Integrated Device Technology, Inc.
2975 Stender Way, Santa Clara, CA - 95054

PRODUCT/PROCESS CHANGE NOTICE (PCN)

PCN #: **G-0206-08** DATE: 6/17/2002
 Product Affected: All square PQFP and TQFP packages shipped in Tape and Reel
 Date Effective: 9/17/2002

ATTACHMENT - PCN #: G-0206-08

Detail of Change: This change will be implemented on all square PQFP and TQFP packages.

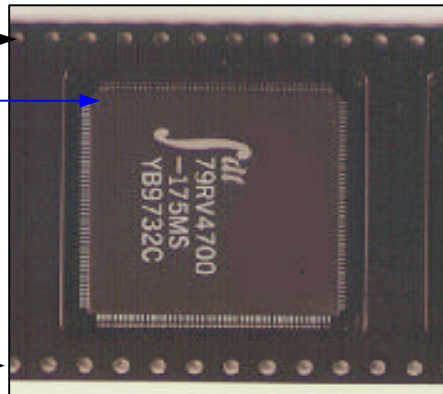
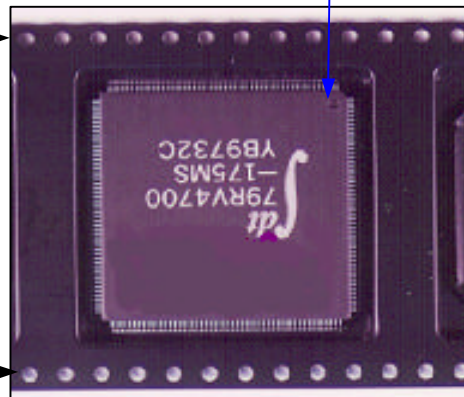
- Die Technology
- Wafer Fabrication Process
- Assembly Process Pin 1 orientation of all square PQFP and TQFP packages shipped in Tape and Reel packaging will be changed to comply with current EIA Standards (EIA-481-2-A) requirement.
- Equipment
- Material
- Testing
- Manufacturing Site Additional label will be placed on the intermediate box (pizza box) to alert customer of this change. Please see attachment for details.
- Data Sheet
- Other - Packaging

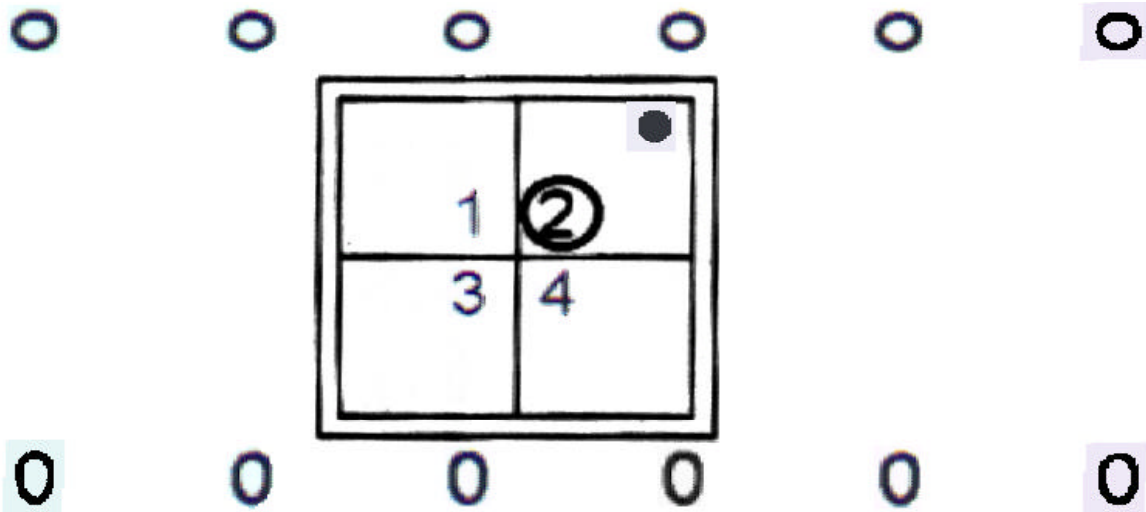
Additional label will be placed on the intermediate box (pizza box) to alert customer of this change.
Label will be placed starting (ww38) 9/17/2002 until 9/17/2003.

Additional label will be placed on the intermediate box (pizza box) to alert customer of this change.

● Pin One in Quadrant 2
